Date: 5-November-2004

The following is a response to questions regarding the Summer Infant PZK201AT video transmitter, our test number 207-04.

13:54:50 APR 14, 2004 CHANNEL B AUDIO CARRIER
207-04 SUMMER INFANT 900MHZ FM TX

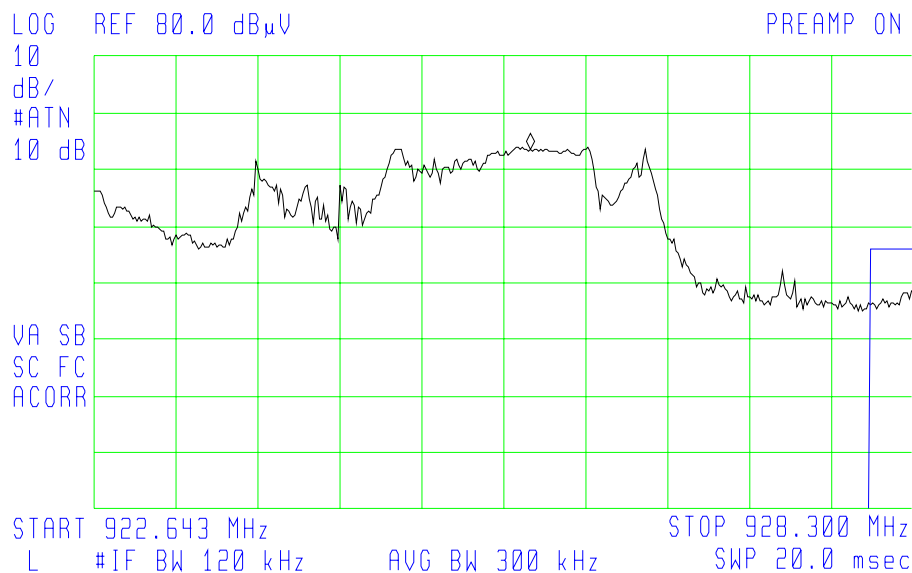
Response to item 3 of an email from Katie Hawkins to Sid Sanders:

The following is a plot taken during the testing showing the upper audio signal with the band edge shown as the limit line on the right side of the plot.

FREQ 925.7 MHz
PEAK 64.6 dB μ V
QP 62.4 dB μ V
AVG NOT SELECTED
